Well Name: MARTHA AIK FEDERAL	Well Location: T22S / R31E / SEC 11 / NESE / 32.404227 / -103.741103	County or Parish/State: EDDY / NM
Well Number: 2	Type of Well: OIL WELL	Allottee or Tribe Name:
Lease Number: NMNM65417	Unit or CA Name:	Unit or CA Number:
US Well Number: 3001526650	Operator: EOG RESOURCES INCORPORATED

**Notice of Intent****Sundry ID:** 2875119**Type of Submission:** Notice of Intent**Type of Action:** Plug and Abandonment**Date Sundry Submitted:** 09/23/2025**Time Sundry Submitted:** 11:13**Date proposed operation will begin:** 10/01/2025**Procedure Description:** EOG proposes to P&A this wellbore using the attached procedure. Current and proposed wellbore schematics attached.**Surface Disturbance****Is any additional surface disturbance proposed?:** No**NOI Attachments****Procedure Description**

Martha AIK Federal #2 – P&A Procedure

**APPROVED by Long Vo**  
**Petroleum Engineer**  
**Carlsbad Field Office**  
**575-988-50402**  
**LVO@BLM.GOV**

## Current Wellbore Diagram:

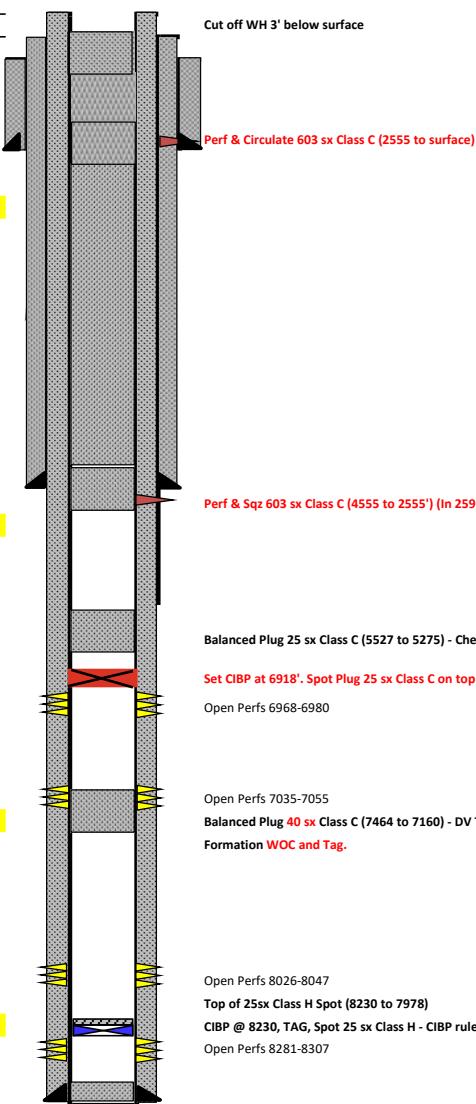
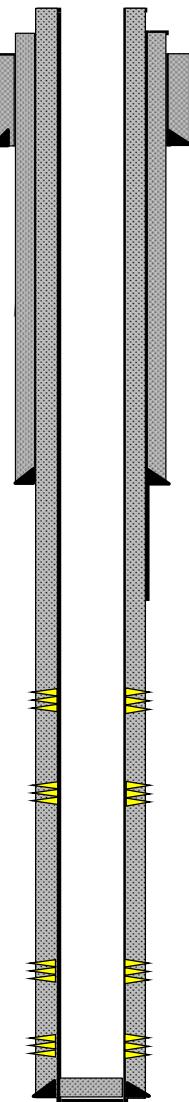
\*Run CBL from CIBP to surface.

Balanced Plug 25 sx Class C (5527 to 5275) - Cherry Canyon Formation

Set CIBP at 6918'. Spot Plug 25 sx Class C on top (Leak Test CIBP)

Submit results to BLM.

Balanced Plug 40 sx Class C (7464 to 7160) - DV Tool &amp; Brushy Canyon Formation WOC and Tag.

REVISED

8. Pick up, set balanced plug w/ **40 sx** Class C from 7464 to 7160 for Brushy Canyon Formation & DV Tool Regulations. **WOC and Tag**.
9. **RIH, set CIBP at 6918'. Spot 25 sxs on top class C. Leak test CIBP, bubble test.**

10. Pick up, set balanced plug w/ 25 sx Class C from 5527 to 5275 for Cherry Canyon Formation.
11. Pick up, perf & squeeze plug w/ **603 sx** Class C from 4555 to 2555. **WOC and Tag. (In 259 sxs/ Out 344 sxs)**

12. Pick up, perf & circulate plug w/ **603 sx** Class C from **2555 to surface. Verify at surface.**
13. Cut off WH 3' below surface, verify cement to surface, and weld on below ground P&A marker.
